DEVIATION REQUEST (Attach diagrams, figures, and other documentation to clarify request)

A deviation from the standards of or in Appendix F, Standard Drawings, **SD 4-4, Urban Residential Collector** and **Table 2-7. Roadway Design Standards for Urban Collectors and Locals-** of the Engineering Criteria Manual (ECM) is requested.

Justification for the requested deviations for Southern Rail Point and Pacific Rail Point include:

Figure 2-15. Typical Urban Residential Collector Cross Section Traffic volumes up to 10,000/day

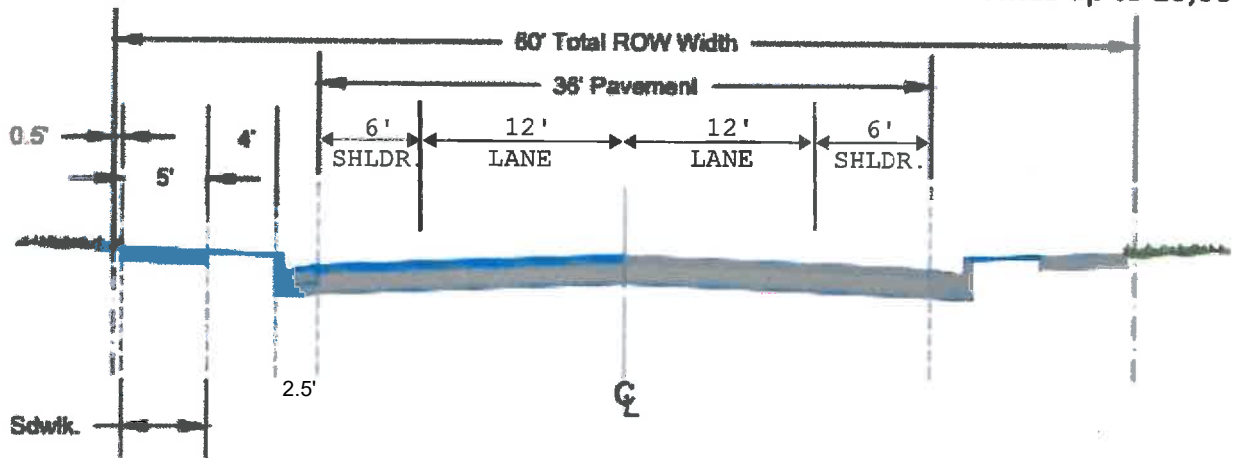
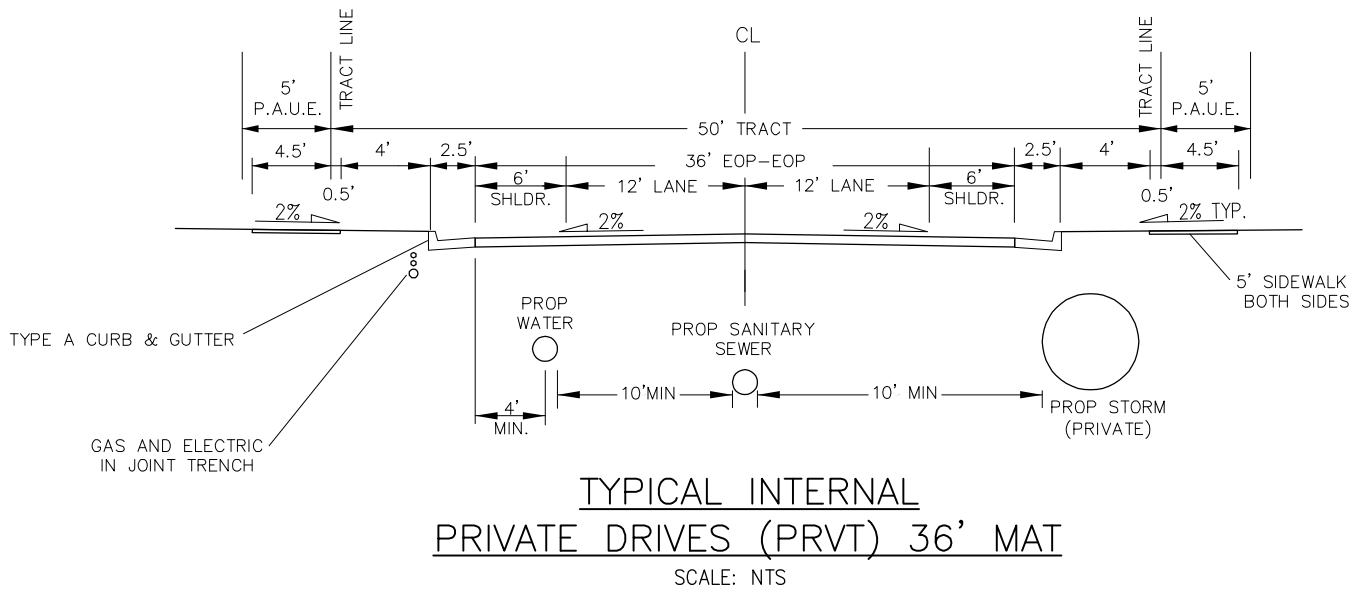
A deviation from the standard Urban Residential Collector Roadway Cross Section for Southern Rail Point and Pacific Rail Point is requested. The standard cross section includes two travel lanes (12') and two shoulders (6') within a 36-foot wide pavement mat; two 2.5-foot curb and gutter at the end of the pavement mat; two four (4) foot (typical) landscape/tree lawns; two five (5) foot detached sidewalks all within a 60-foot ROW.

The proposed private road cross section includes the following deviation(s) from standard ECM Standards for an urban residential collector section. Requesting;

- 50-foot tract dedicated for private road and utility use. Typical cross section is within a 60-foot Public ROW.
- 36 foot pavement width, where typical cross section has a 36' pavement width. No Change.

- Two 12-foot travel lanes with two 6' shoulders, where typical cross section has two 12-foot travel lanes with two 6' shoulders. No Change
- 5-foot detached sidewalk, where typical cross section has 5' detached sidewalks, No Change. However, the sidewalk is outside of the 50-foot tract. An additional 5 foot Public Access Utility Easement has been provided to accommodate the portion of sidewalk lying outside the tract. Attached sidewalk is not requested because it may cause problems with future development driveway cuts and ADA ramps.

- 200' minimum centerline radius (standard for urban local roadways) whereas typical cross section is 565' minimum centerline radius.
- 25 MPH design speed/25 MPH posted speed (urban local), whereas typical cross section is 40/35 MPH.

- Typical cross section intersection spacing is 660' or 330' when intersecting local roadways. The layout of all of the commercial lots is not known at this time. Therefore, a deviation for the future applications will be necessary. Access spacing will also need to be considered. (Table 2-35)

This request has been determined to have met the criteria for approval. A deviation from **Chapter 2, and Appendix F, SD 4-4** of the ECM is hereby granted based on the justification provided.
